# INITIAL FIRE SAFETY INSPECTION REPORT

**SQ Birichina Ltd Unit 2 - Extension (previously SQ Colblanc Limited)**

**RSC ID: 25621**

**Date: 31-Oct-2024**

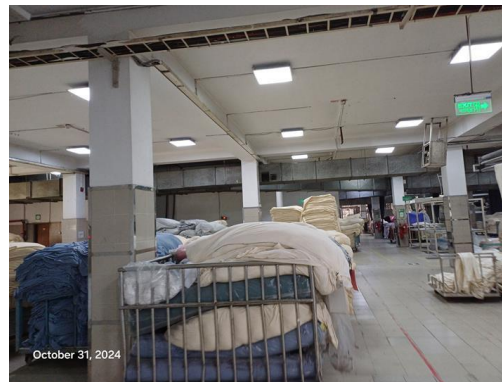
| SI No. | Category        | Findings                                                                                                                                                                                                                                                                                             | Required Action                                                                                                                                                                                                                                                                                                                                                                                                                                                                                                                                                                                                                                         | Remediation Time Frame |
|--------|-----------------|------------------------------------------------------------------------------------------------------------------------------------------------------------------------------------------------------------------------------------------------------------------------------------------------------|---------------------------------------------------------------------------------------------------------------------------------------------------------------------------------------------------------------------------------------------------------------------------------------------------------------------------------------------------------------------------------------------------------------------------------------------------------------------------------------------------------------------------------------------------------------------------------------------------------------------------------------------------------|------------------------|
| F-1    | Means of Egress | <p>The south-west exit stairs are not separated from work areas and other spaces on each floor by fire rated construction at extended office building.</p> <p>Newly installed fire doors (south-west) manual and certificate need to be kept on-site. Fire doors should be interfaced with FACP.</p> | <p>Provide minimum 1-hr rated doors for buildings with 3 or fewer stories and 1.5-hr fire rated doors for buildings that are 4 or more stories. Seal all unprotected openings to separate the exit stairs from work areas and other building spaces on all floor levels.</p> <p>Ensure that the fire doors are self-closing and positive latching and that they are provided with fire exit (panic) hardware where serving production floors. Provide credible documents and certificates for fire rated doors. If fire doors are required to be held open for functional reasons, provide automatic closing devices tied to the fire alarm system.</p> | Within 3 months        |

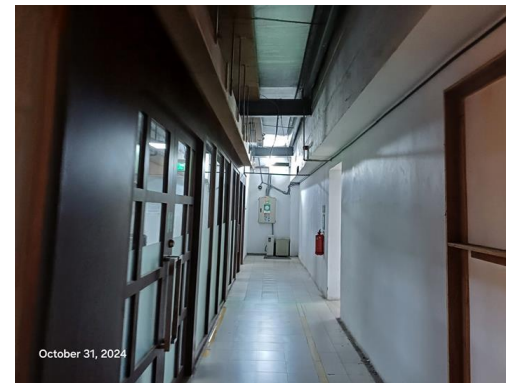
| SI No. | Category                | Findings                                                                                                                                                                | Required Action                                                                                                                                                                                                                                                                                                                                                                                                                              | Remediation Time Frame |
|--------|-------------------------|-------------------------------------------------------------------------------------------------------------------------------------------------------------------------|----------------------------------------------------------------------------------------------------------------------------------------------------------------------------------------------------------------------------------------------------------------------------------------------------------------------------------------------------------------------------------------------------------------------------------------------|------------------------|
| F-5    | Fire Rated Construction | Unsealed penetrations and openings are located in the fire-rated floor/ceiling assemblies due to expansion joint located at 1st floor slab of extended office building. | <p>Provide a minimum 2-hr fire rated shaft to separate the utility risers from each floor level or seal all penetrations and openings in floors/ceiling assemblies by 3-hr fire rated listed/certified materials. The installation of such fire rated materials shall be following certified design.</p> <p>Submit the proposed drawing/design to RSC for review. Once reviewed, install passive fire protection as per reviewed design.</p> | Within 3 months        |

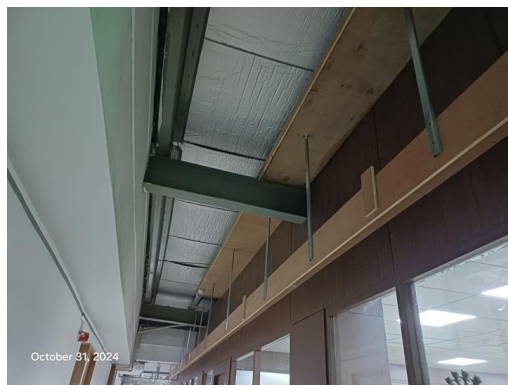
| SI No. | Category                | Findings                                                                                                                                                                                                    | Required Action                                                                                                                                                                                                                                                                      | Remediation Time Frame |
|--------|-------------------------|-------------------------------------------------------------------------------------------------------------------------------------------------------------------------------------------------------------|--------------------------------------------------------------------------------------------------------------------------------------------------------------------------------------------------------------------------------------------------------------------------------------|------------------------|
| F-7    | Fire Rated Construction | Floor to floor separation is not ensured as the extended office building has non-rated structure on 1st floor roof and 6 storied production building has openings without any fire protection on 2nd floor. | Provide a minimum 3-hr fire resistance rating in floors/ceiling assemblies by applying listed/certified materials. The installation of such fire rated materials shall be following certified design. Or, seal the opening adjacent to shed on 2nd floor by fire rated construction. | Within 3 months        |

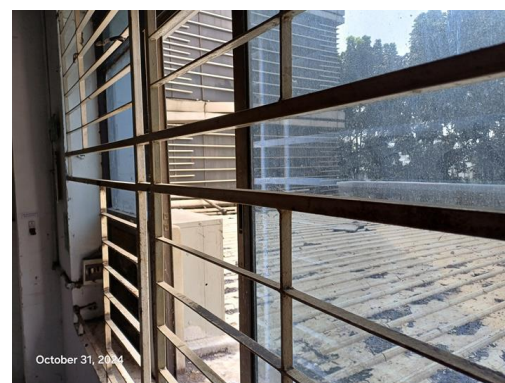
| SI No. | Category        | Findings                                                                                                                    | Required Action                                                                                                                                                                                                                                                                                                                    | Remediation Time Frame |
|--------|-----------------|-----------------------------------------------------------------------------------------------------------------------------|------------------------------------------------------------------------------------------------------------------------------------------------------------------------------------------------------------------------------------------------------------------------------------------------------------------------------------|------------------------|
| F-8    | Means of egress | Egress doors and gates with locking features are provided at office rooms located at 1st floor of extended office building. | <p>Remove locking features from all egress doors and gates. If locks are required for security reasons, utilize special door locking features complying with NFPA 101 and RSC standard 6.8.2.</p> <p>Or, integrate the locking devices with FACP in such a way that upon triggering alarm all door locking mechanism released.</p> | Within 1 month         |
